Access Compliance Report

Public Rights-of-Way

Intersection ID: 16497	Main Street: HAMPTON_AV	Cross Street: PORTLAND_AV	Location: SW
ADA ID: 8C904E0CF2F3	Ramp Type: Combination2Diag	Initial Pass/Fail: Fail	Overall Compliance: No
		Severity Score: 0

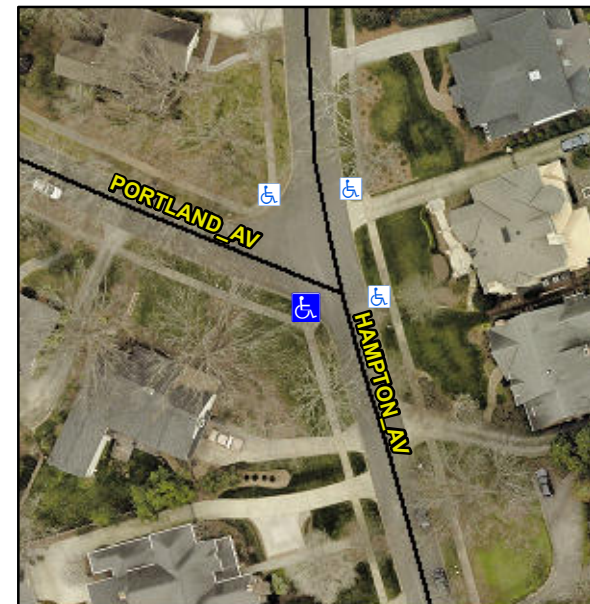
R304.5.1, R304.5.1, R304.5.3, R304.3.2

Compliance	Description	Data	Compliance	Description	Data
N/A	Ramp Length LT (in)	N/A	N/A	Ramp Length RT (in)	123.0
N/A	Ramp Width LT (in)	N/A	No	Ramp Width RT (in)	45.5
N/A	Ramp Slope LT (%)	N/A	No	Ramp Slope RT (%)	9.2
N/A	Ramp XSlope LT (%)	N/A	Yes	Ramp XSlope RT (%)	1.0
N/A	Ramp Length (in)	76.0	Yes	Ramp Slope (%)	7.7
No	Ramp Width (in)	46.5	No	Ramp XSlope (%)	6.7
N/A	Flare Type LT	N/A	N/A	Flare Type RT	N/A
N/A	Flare Slope LT (%)	N/A	N/A	Flare Slope RT (%)	N/A
N/A	Flare Traversable LT?	N/A	N/A	Flare Traversable RT?	N/A
N/A	Landing Length (in)	N/A	N/A	DWS Provided?	N/A
N/A	Landing Width (in)	N/A	N/A	DWS Contrast?	N/A
N/A	Landing Slope (%)	N/A	N/A	DWS Length (in)	N/A
N/A	Landing X Slope (%)	N/A	N/A	DWS Full Width?	N/A
N/A	Landing Curb? (Y/N)	N/A	N/A	DWS Offset (in)	N/A
N/A	Shared Landing?	N/A			
N/A	Gutter Ponding?	N/A	N/A	Gutter Slope (%)	N/A
N/A	Gutter Lip Ht (in)	N/A	N/A	Gutter X Slope (%)	N/A
N/A	Painted X Walk1?	No	N/A	Painted X Walk2?	No

Remove & Replace Curb Ramp With Two New Directional Ramps or Equivalent.
